AGENDA
City of Salmon Arm
Development and Planning Services
Committee

Subject: Development Permit Application No. 443 (Form and Character)
 Civic Address: 2800 10 Avenue (TCH) SW
 Owner/Applicant: Blaneil Cranbrook Holdings Ltd.

Subject: Development Permit Application DP-441 (Residential)

Drawing Title
BUILDING #2
FLOOR PLAN

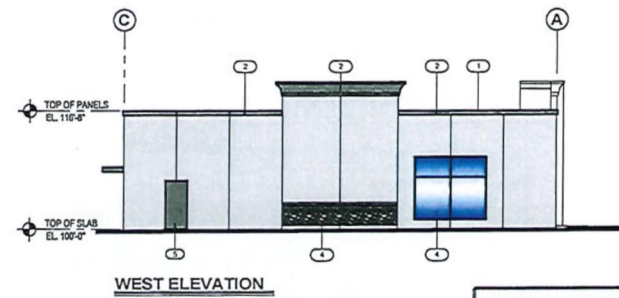
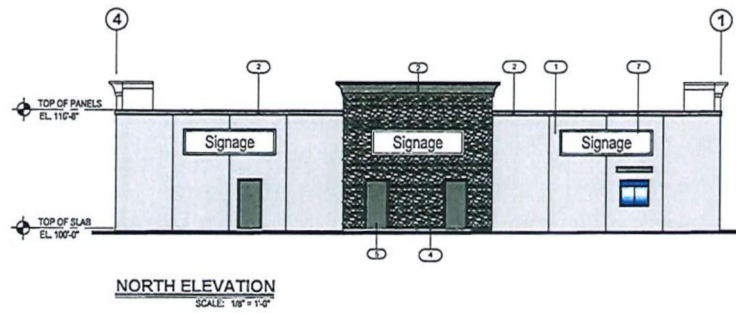
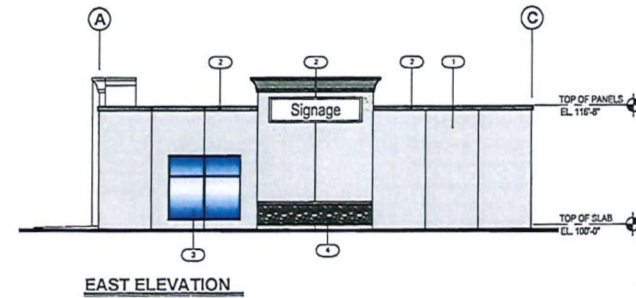
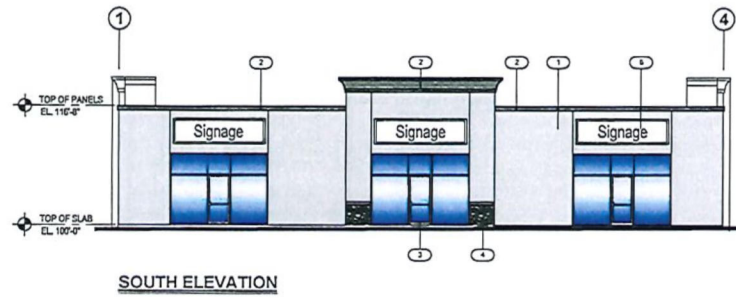
- along the north facing wall (highway side) of Building 2, rock treatment from the bottom of the building to the roof line for the centre section.
- the inclusion of lighting on the outside of building similar to the samples provided by the applicant."

2	2022-06-10	North Elevation Revised
1	2022-05-10	Issued for preliminary GP review

Drawing Title
LANDSCAPE PLAN

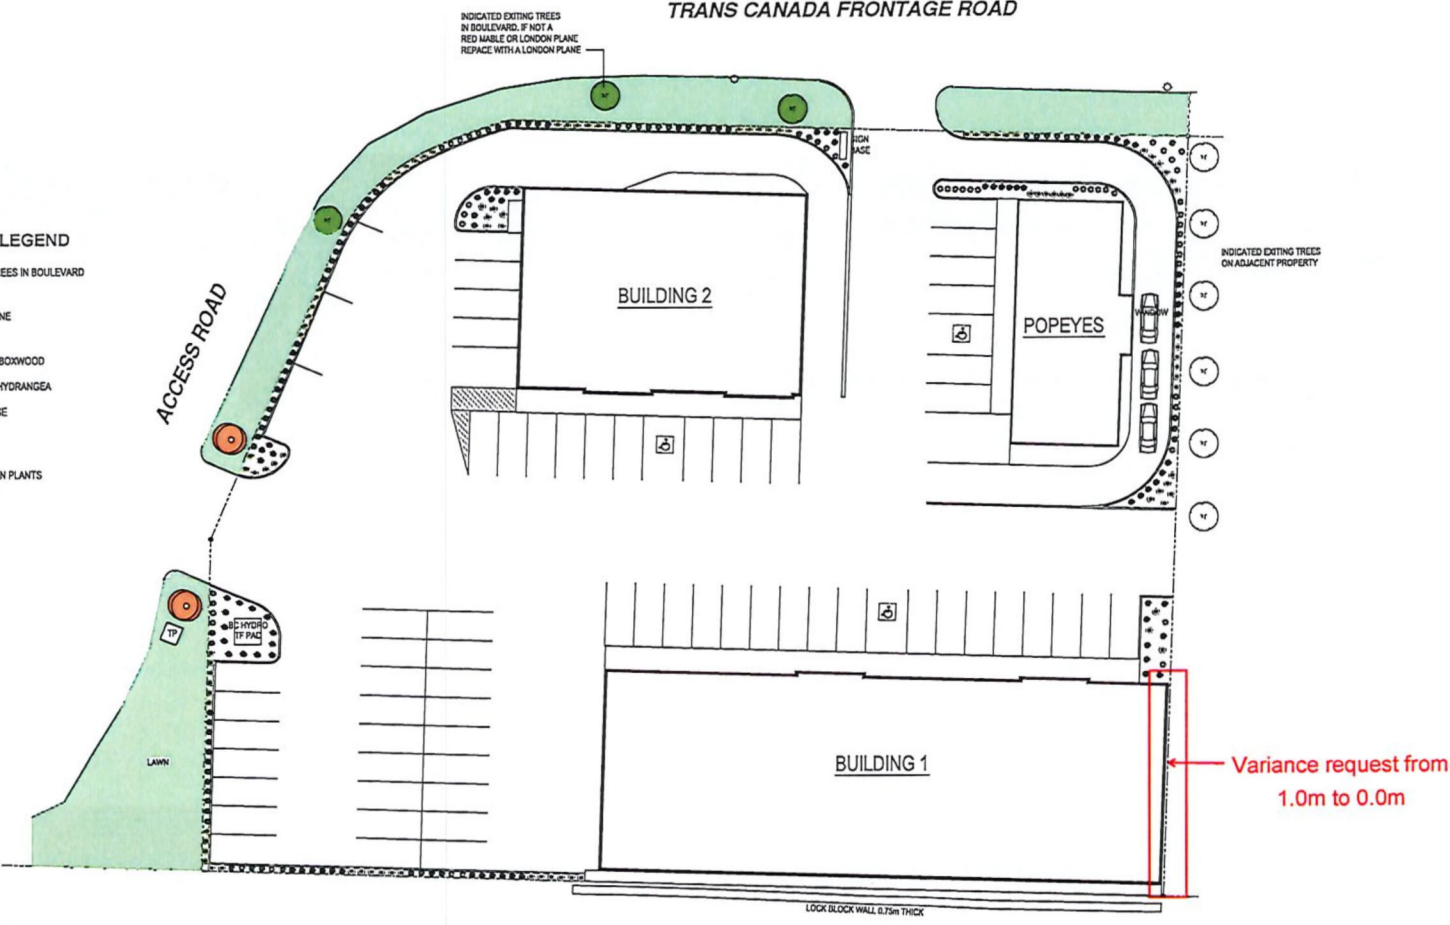
The applicant has worked with staff and been amenable to revise their proposal to align with the OCP Guidelines and the DRP recommendations. Specifically, the applicant amended the landscape plan to address tree locations and plantings, and as per the recommendation of the DRP, the applicant amended the drawings to include the rock detail on the north side of Building 2 to improve the building face and highway exposure. Additionally, the applicant has committed to install the lighting as per the examples provided in the Development Permit application package.

2	2022-05-18	Landscape revised
1	2022-05-10	Issued for preliminary DP review
